**BEFORE THE HEARINGS PANEL
FOR THE QUEENSTOWN LAKES PROPOSED DISTRICT PLAN**

IN THE MATTER of Hearing Stream 14:
Wakatipu Basin
hearing and
transferred Stage 1
submissions related to
Arrowtown and Lake
Hayes

**REBUTTAL EVIDENCE OF BRIDGET MARY GILBERT
ON BEHALF OF QUEENSTOWN LAKES DISTRICT COUNCIL**

LANDSCAPE

Figure 11: Proposed mapping amendment (including Queenstown Trail Setback). This mapping incorporates the Precinct mapping amendment recommended in section 32 of my EIC.

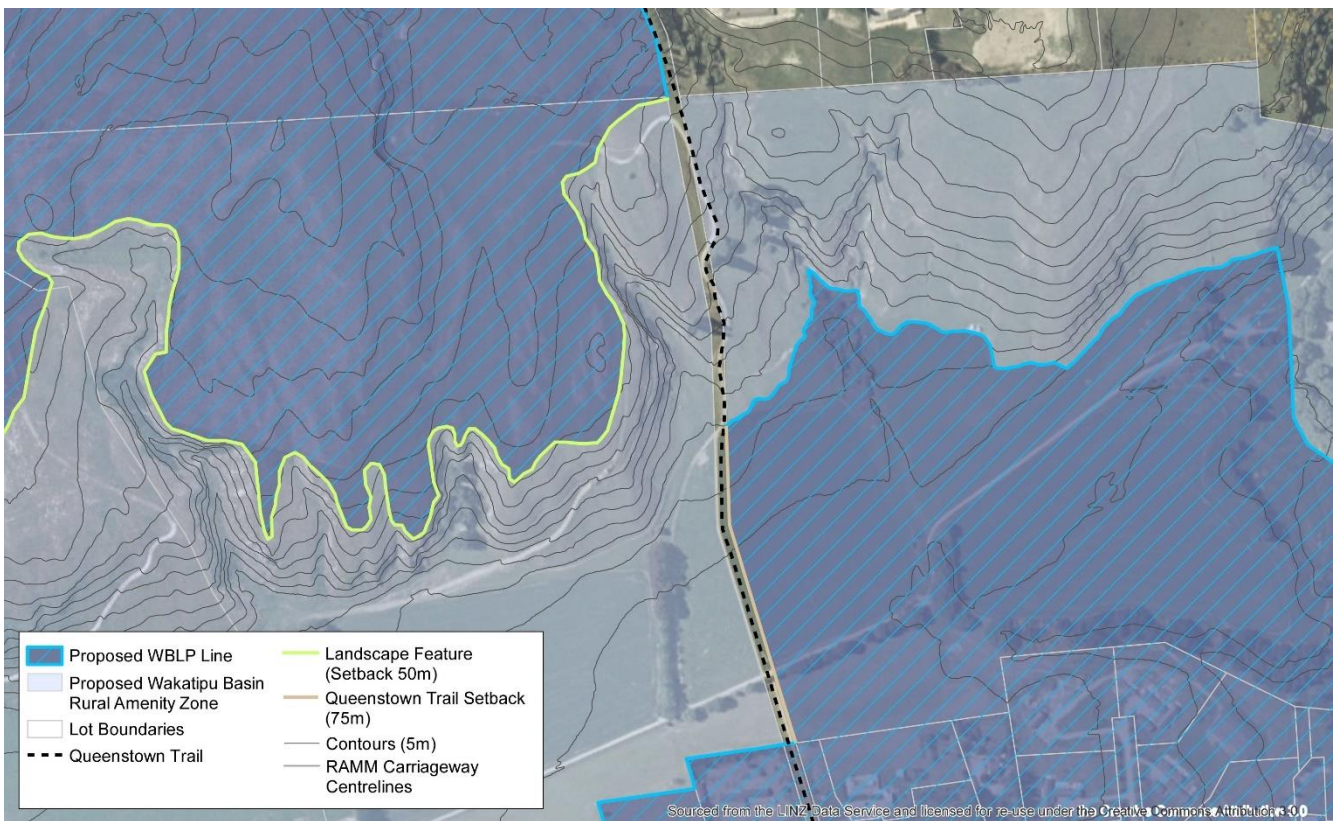
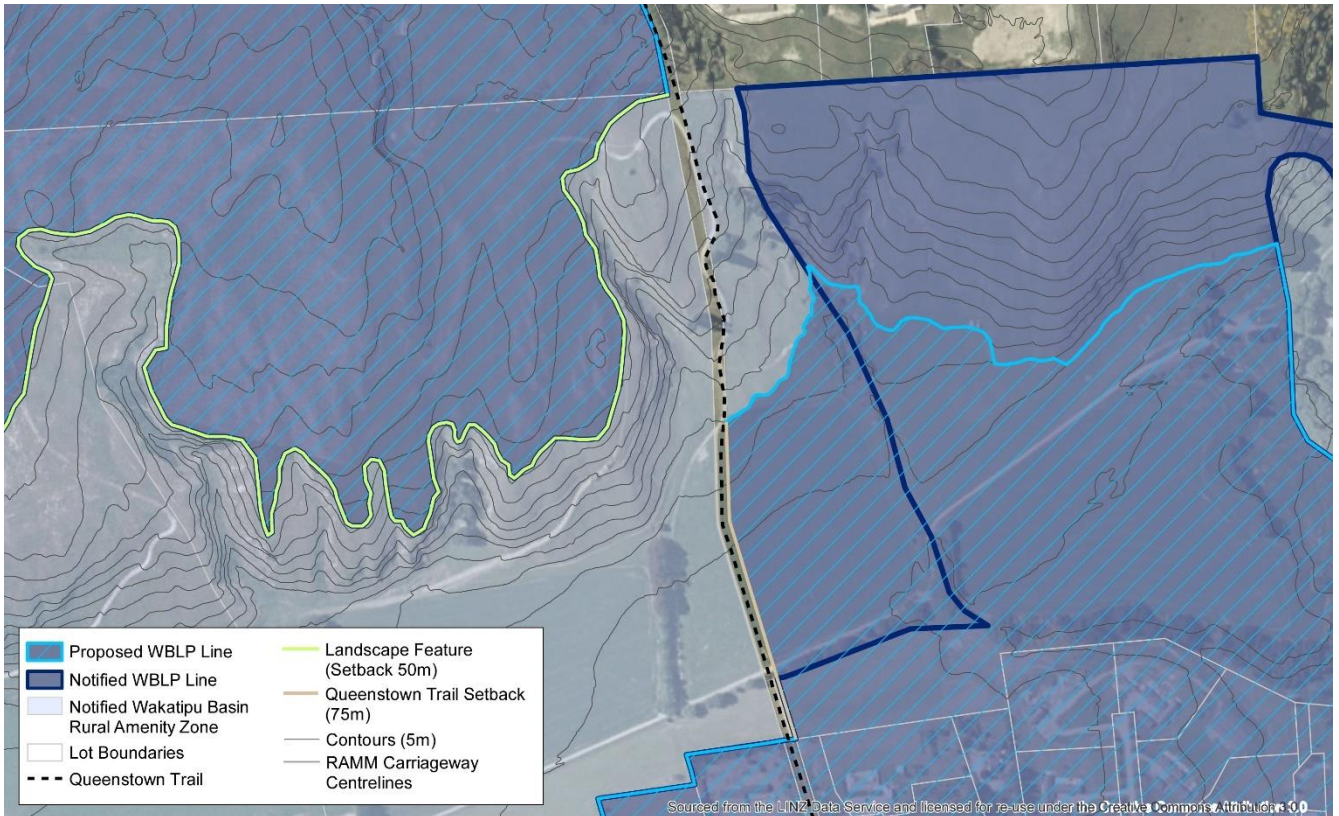
10.22 With respect to the western Precinct boundary, having revisited the area, I agree with Mr Skelton³⁶ (and Ms Hadley) that the alignment along an ephemeral tributary does not comprise a defensible edge. For this reason, I recommend that the western edge of the Precinct should be realigned to coincide with the east side of the Queenstown Trail, with a 75m Trail Setback introduced along this edge of the Precinct that requires all buildings to be set back a minimum of 75m from the Trail boundary.

10.24 In my opinion, the Queenstown Trail Setback rule, together with the Precinct assessment criteria that require the consideration of the effects of development on visual amenity from public places and the effects of development on views to ONFs and ONLs from public places, will ensure that such development does not detract from the landscape and visual amenity values associated with the Queenstown Trail. I also consider that the combination of these devices (i.e. the legally protected Trail and 75m Trail Setback) will comprise a legible defensible edge for rural residential development of the scale and character anticipated by the Precinct.

Figure 13: Extent of Mr Espie's 'new' Precinct shown in green outline. (Source B Espie EiC.)

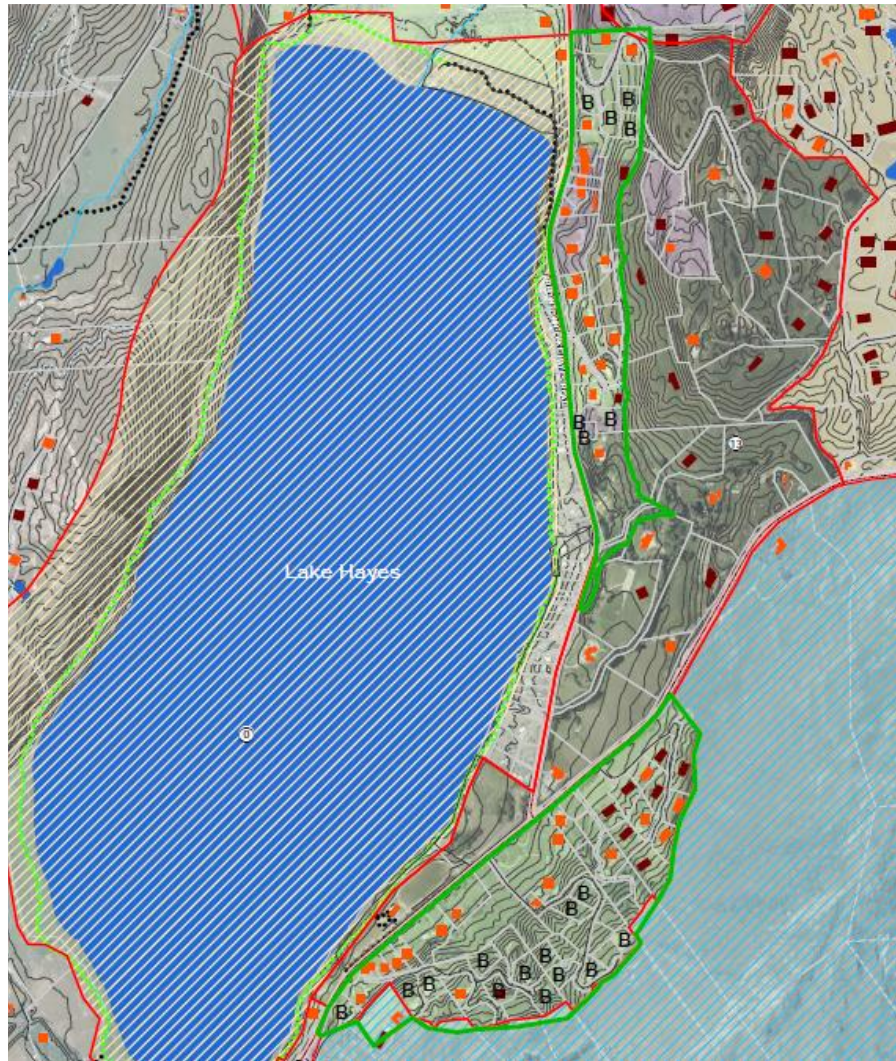
14.9 I do not consider that ‘filling in the gaps’ promotes a defensible edge along the eastern side of Arrowtown Lake Hayes Road. Rather, within the context of a relatively evenly sloping hillside where there are no identifiable defensible edges and the area enjoys highly attractive elevated views out over Lake Hayes and the wider Basin/mountain landscape, I consider that introducing a new Precinct in the manner supported by Mr Espie would significantly increase the risk of development creep. In my opinion (and drawing for the analysis provided in my evidence in chief at Section 43), such an outcome would comprise a significant adverse landscape and visual amenity effect.
